DESIG	HE	DRAWN BY	DART AEROSPACE LTD HAWKESBURY, ONTARIO, CANADA	
CHEC	KED	APPROVED	DRAWING NO.	REV. A
	4	<b>**</b>	DSI 9171 SHEET	1 OF 1
DATE			TITLE	SCALE
99.10.29			BEARPAW CLAMP	NTS
Α		99.10.29	NEW ISSUE

## DART SERVICE INSTRUCTION

AMEND THE FOLLOWING INSTALLATION DRAWING: D205-564 REV B

CANADIAN STC: SH96-42 US FAA STC: SR00571NY

<u>SECTION A-A</u>
TYPICAL CLAMPING DETAIL

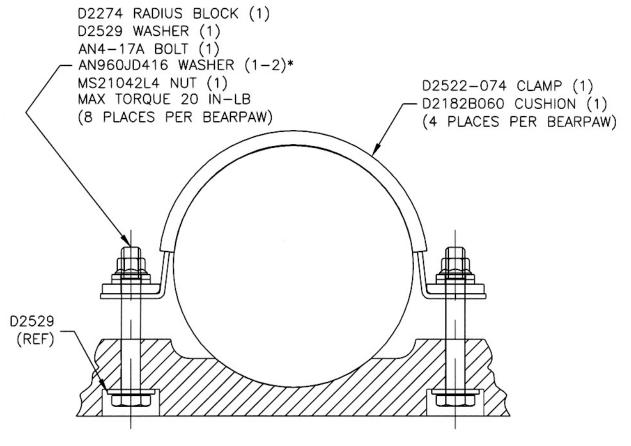
REPLACE D2522 CLAMP WITH D2522-074 CLAMP.
REPLACE AN4-13A BOLTS WITH AN4-17A BOLTS.
\*ADDITIONAL AN960JD416 WASHERS MAY BE ADDED UNDER NUT TO ENSURE 2-4 THREADS IN SAFETY
